STATE OF OHIO
DEPARTMENT OF TRANSPORTATION
MED-303-13.90/14.96
HINCKLEY TOWNSHIP
MEDINA COUNTY

3 ADDENDUM 3: 3-WAY STOP REMOVED

BRIDGE REPLACEMENT OVER EAST BRANCH OF ROCKY RIVER. CULVERT REPLACEMENT 0.2 MILES WEST OF STATE ROAD BY MEANS OF OPEN CUT. WORK ALSO INCLUDES GUARDRAIL REPLACEMENT, RETAINING WALL, DRAINAGE STRUCTURES, AND MINIMAL PAVEMENT WORK.

**MAINTENANCE OF TRAFFIC
DETOUR MAP**

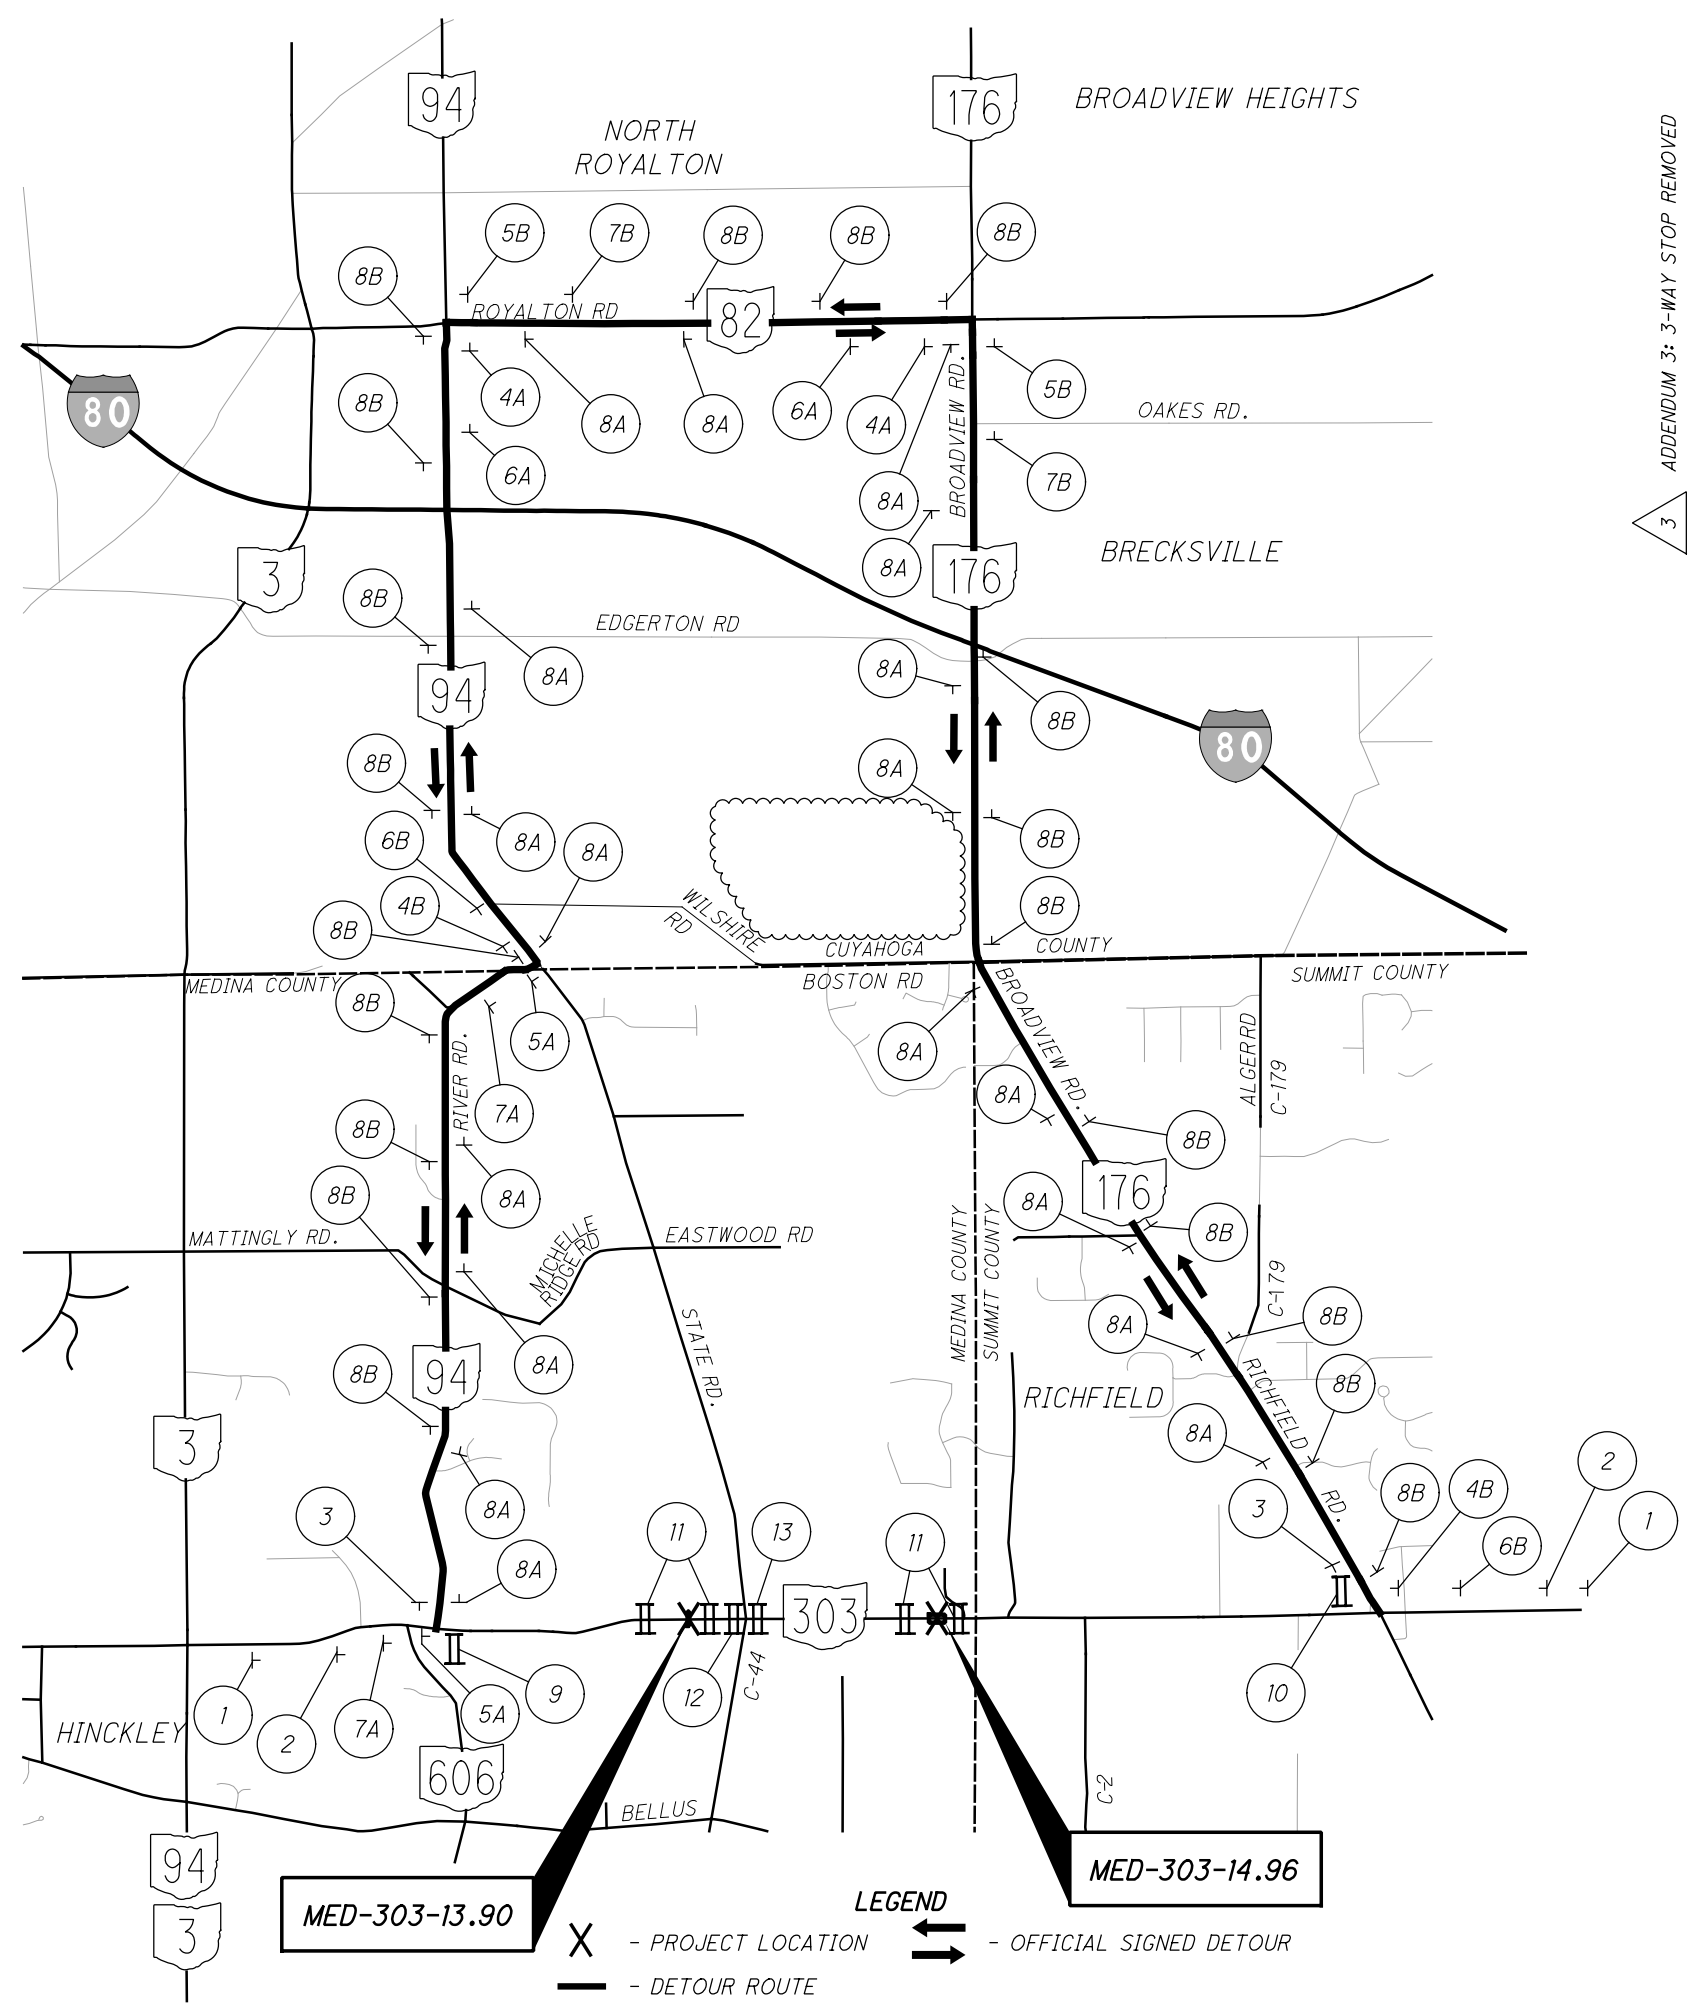
ADDENDUM 3: 3-WAY STOP REMOVED

WALL PLAN
 SOLDIER PILE AND LAGGING WALL
 ALONG SR-303 WEST OF STATE ROAD

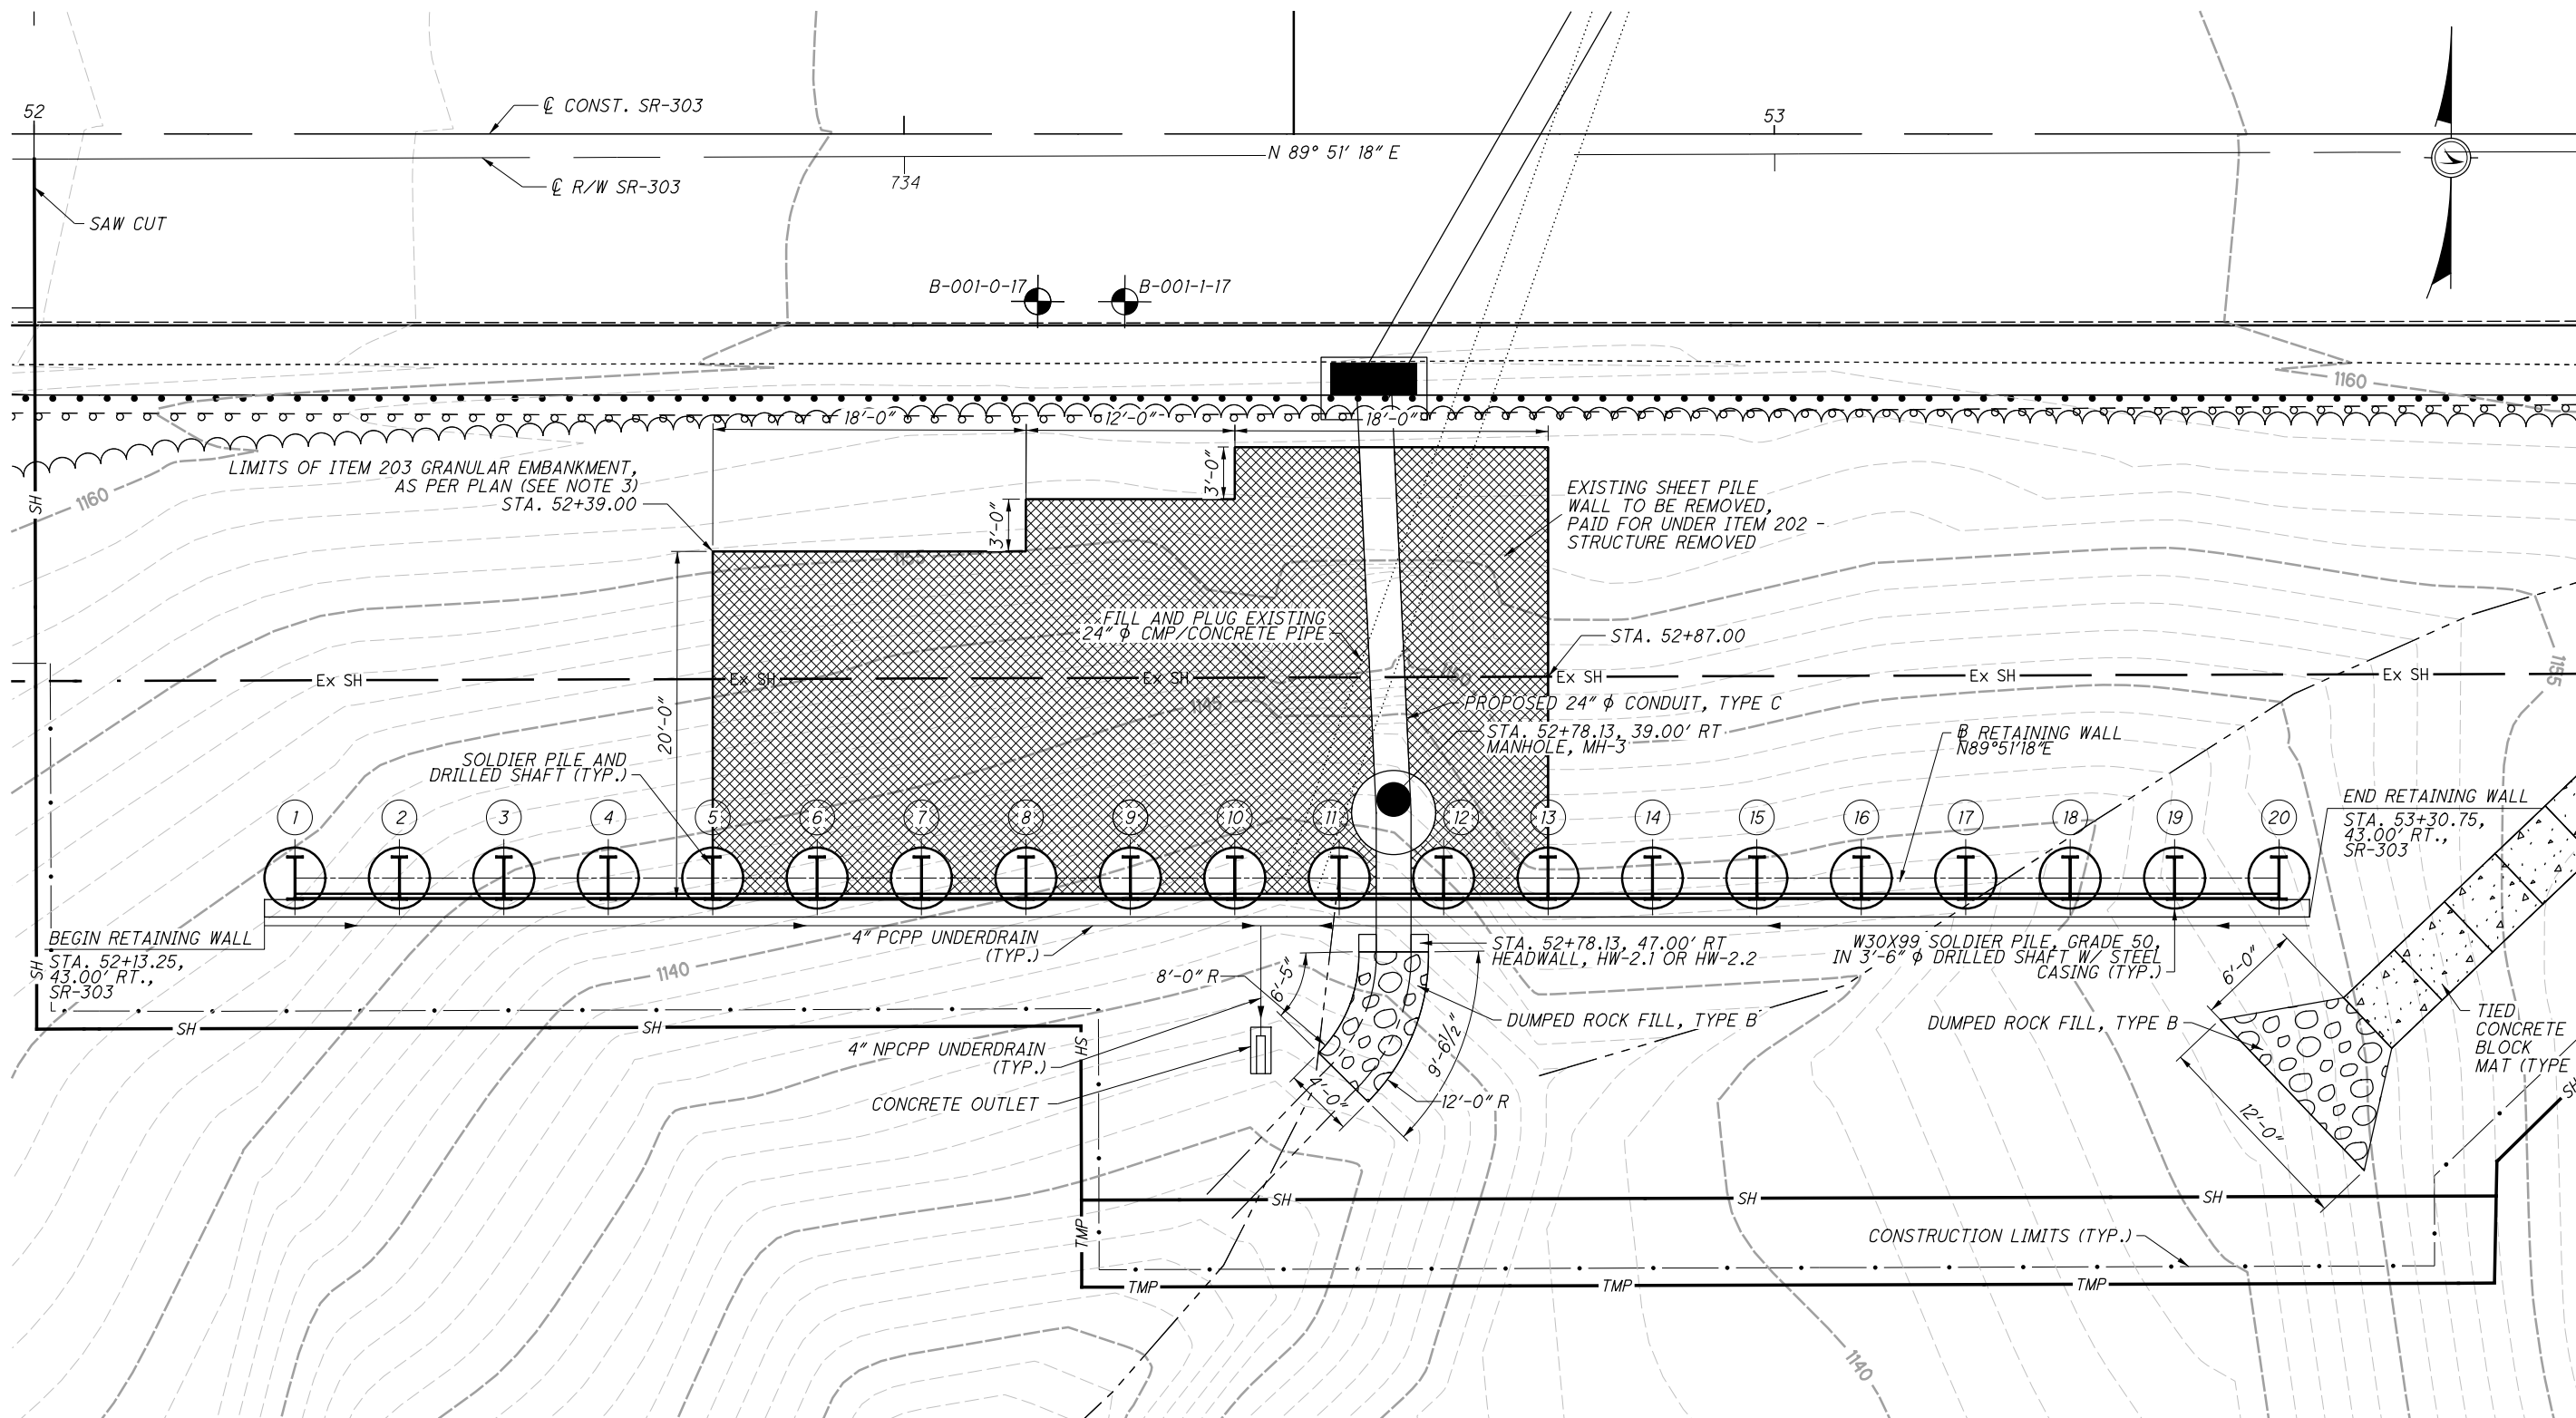
4 ADDENDUM 4: GRANULAR EMBANKMENT UNIT CHANGE

- NOTES:**
1. FOR WALL ELEVATION, SEE SHEET 5/8.
 2. FOR WALL DETAILS, SEE SHEET 7/8.
 3. BACKFILL OF THE RETAINING WALL SHALL BE PLACED PRIOR TO CONSTRUCTING THE CAST-IN-PLACE FACING. THE BACKFILL SHALL CONSIST OF ITEM 203 ROADWAY, MISC. 3 GRANULAR EMBANKMENT, TYPE B, EXCEPT WHERE IT IS NOTED THAT ITEM 203 GRANULAR EMBANKMENT, AS PER PLAN, SHALL BE USED. THE ITEM 203 GRANULAR EMBANKMENT, AS PER PLAN, SHALL BE A SELECT GRANULAR BACKFILL AND SHALL CONFORM TO ODOT CMS ITEM 703.11 STRUCTURAL BACKFILL TYPE 2. THE SELECT GRANULAR BACKFILL SHALL EXTEND FROM THE BASE OF THE WALL TO THE INTERSECTING PROPOSED GRADE LINE AND TO THE BOTTOM OF THE EXCAVATION.

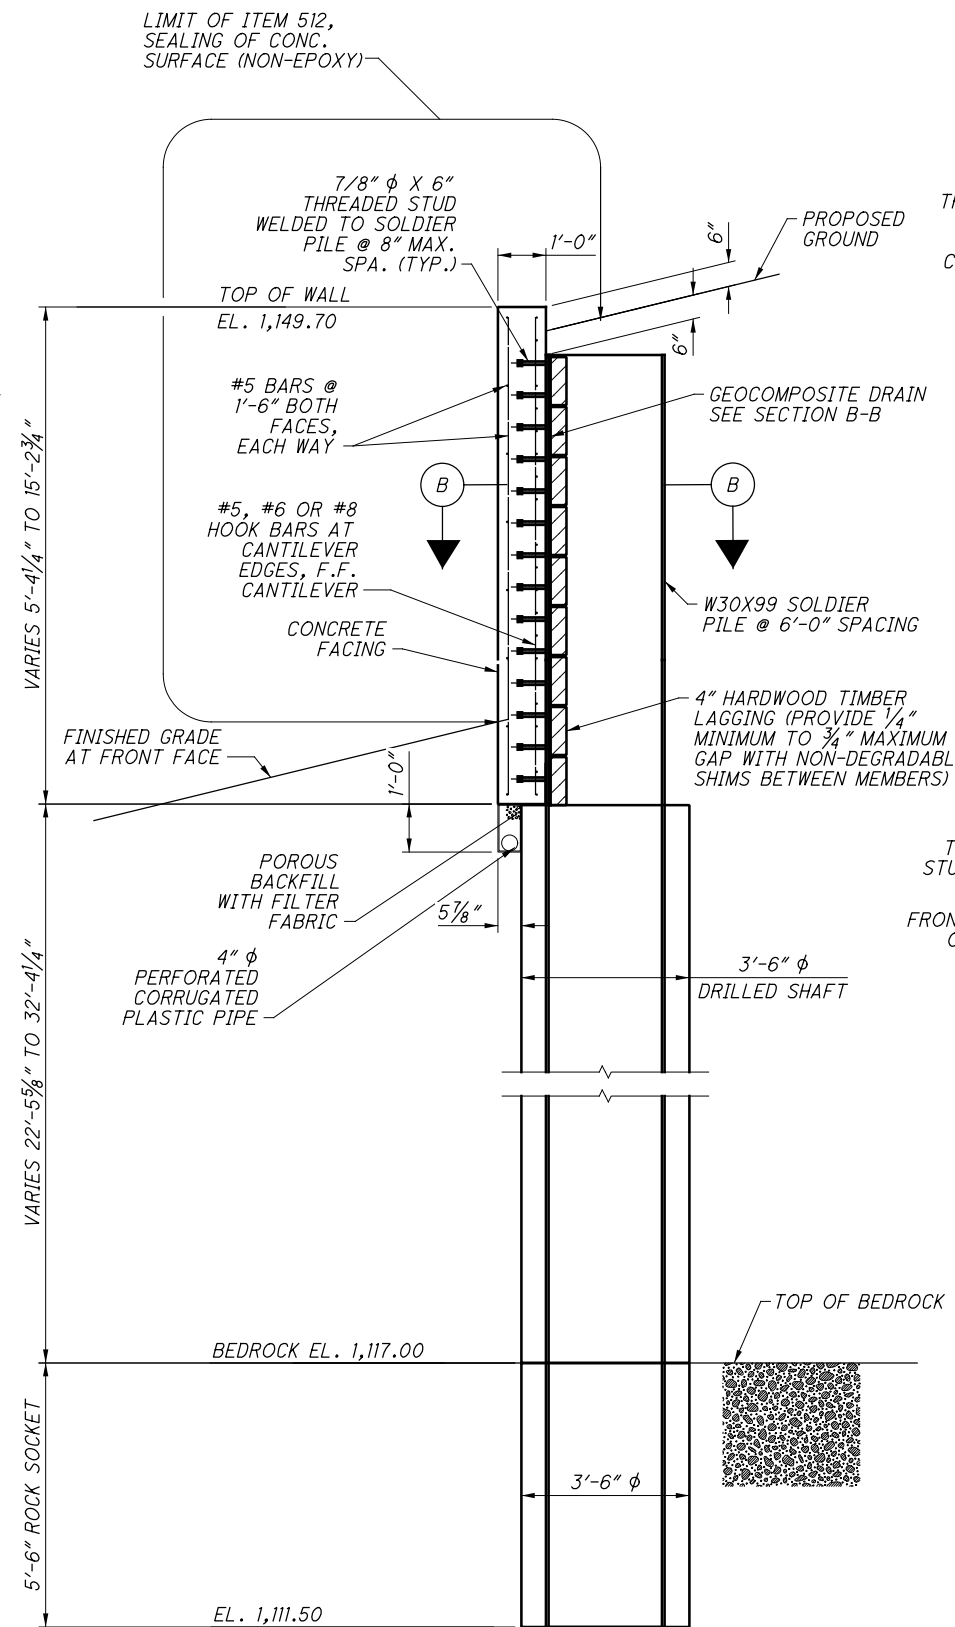
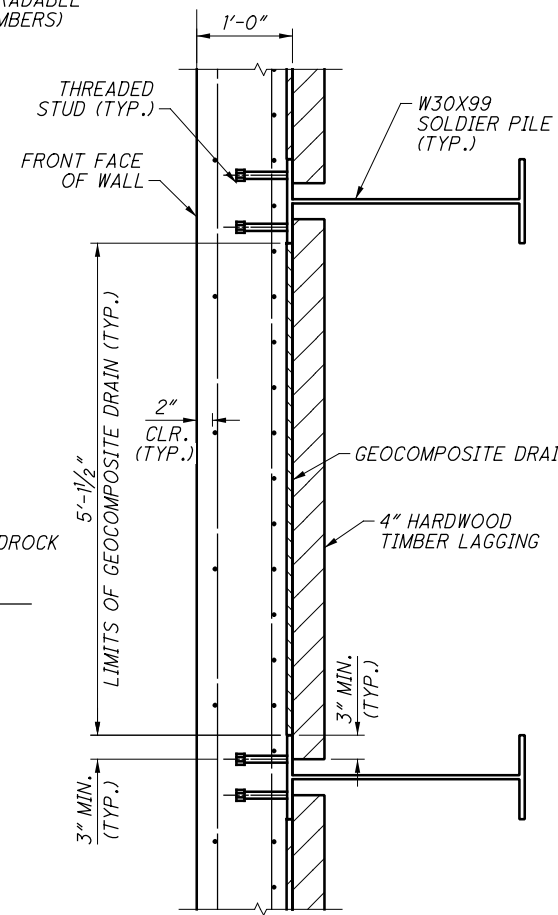
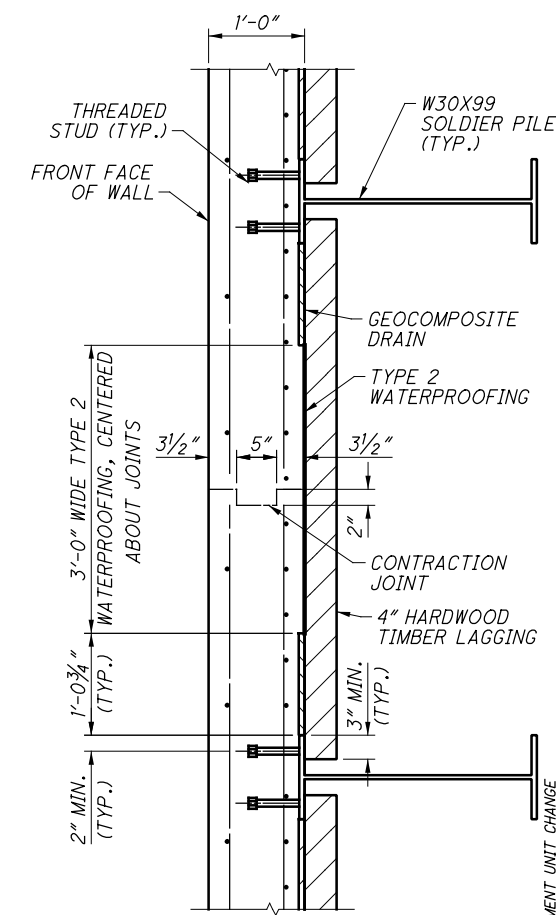
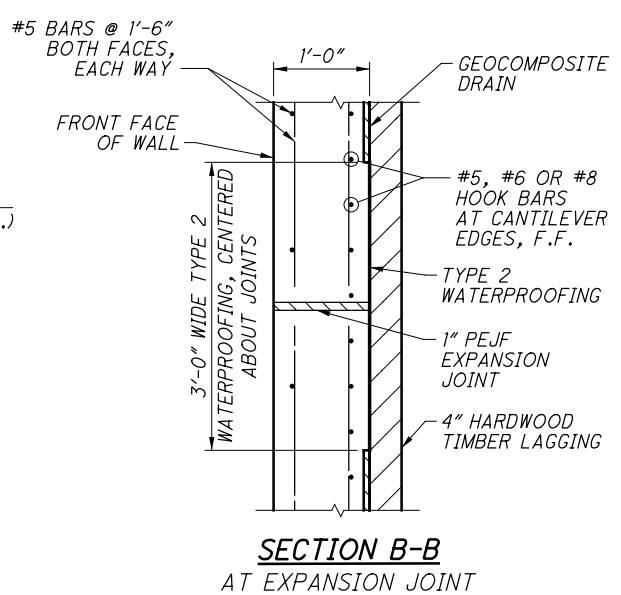
DESIGN AGENCY 2475 Sugar Grove Rd., SE Lancaster, Ohio 43130 (740) 687-5542 Phone - (740) 687-0066 Fax	DATE 9/19/19	STRUCTURE FILE NUMBER
DRAWN JBM	REVIEWED MUR	CHECKED JAH	DESIGNED JBM
WALL TYPICAL SECTION SOLDIER PILE AND LAGGING WALL ALONG SR-303 WEST OF STATE ROAD			
MED-303-13.90/14.96		PID No. 94440	
ADDENDUM 4: GRANULAR EMBANKMENT UNIT CHANGE			
7 / 8			
32 / 60

1. FOR WALL PLAN, SEE SHEET 4/8.
2. FOR WALL ELEVATION, SEE SHEET 5/8.
3. STUDS INCLUDED IN PRICE OF ITEM 507 - STEEL PILES, MISC.: SOLDIER PILES.
4. FOR LOCATION OF SECTION A-A, SEE SHEET 5/8.
5. BACKFILL RETAINING WALL WITH ITEM 203 - (ROADWAY, MISC.): GRANULAR MATERIAL, TYPE B, EXCEPT WHERE NOTED TO USE ITEM 203 - GRANULAR EMBANKMENT, AS PER PLAN.
6. BACKFILL MUST BE COMPLETED PRIOR TO INSTALLING THE CIP WALL FACING.

EXCAVATION CLASSIFICATION DETAIL

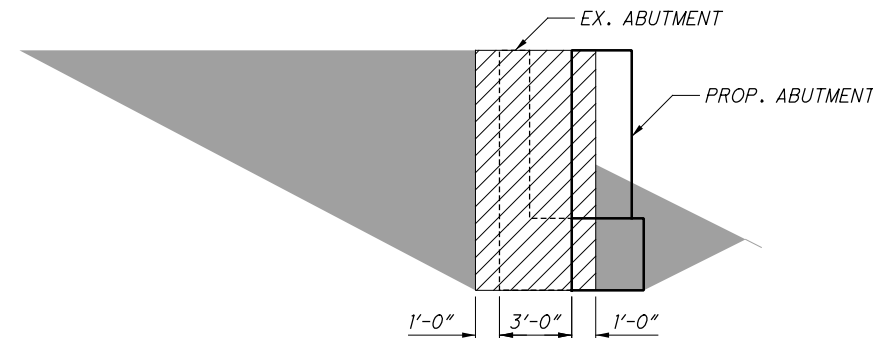
3 ADDENDUM 3: REDUCED PIER PILE REMOVAL TO 2 FEET BELOW GRADE.

THE WORK CONSISTS OF THE REMOVAL OF THE EXISTING BRIDGE STRUCTURE FOR MED-303-1496. REMOVE EXISTING SUPERSTRUCTURE, INCLUDING WEARING COURSE, PIERS, ABUTMENTS AND FOOTINGS IN THEIR ENTIRETY. EXISTING PIER PILES SHALL BE REMOVED TO A MINIMUM OF 2 FEET BELOW EXISTING STREAM BED ELEVATION. EXISTING ABUTMENT PILES SHALL BE REMOVED TO A MINIMUM OF 1 FOOT BELOW THE BOTTOM OF PROPOSED FOOTING AS TO AVOID INTERFERENCE WITH PROPOSED STRUCTURE. IF INTERFERENCE IS UNAVOIDABLE, COMPLETELY REMOVE EXISTING ABUTMENT PILES. THE CONTRACTOR HAS THE OPTION OF COMPLETELY REMOVING EXISTING ABUTMENT PILES IN LIEU OF PARTIAL REMOVAL OF PILES IF THERE IS NO INTERFERENCE TO THE PROPOSED SUBSTRUCTURE. PAYMENT FOR ALL LABOR, EQUIPMENT, AND MATERIALS NECESSARY TO COMPLETE THIS WORK SHALL BE PAID FOR AT THE CONTRACT LUMP SUM PRICE FOR ITEM 202: STRUCTURE REMOVED, OVER 20 FOOT SPAN, AS PER PLAN.
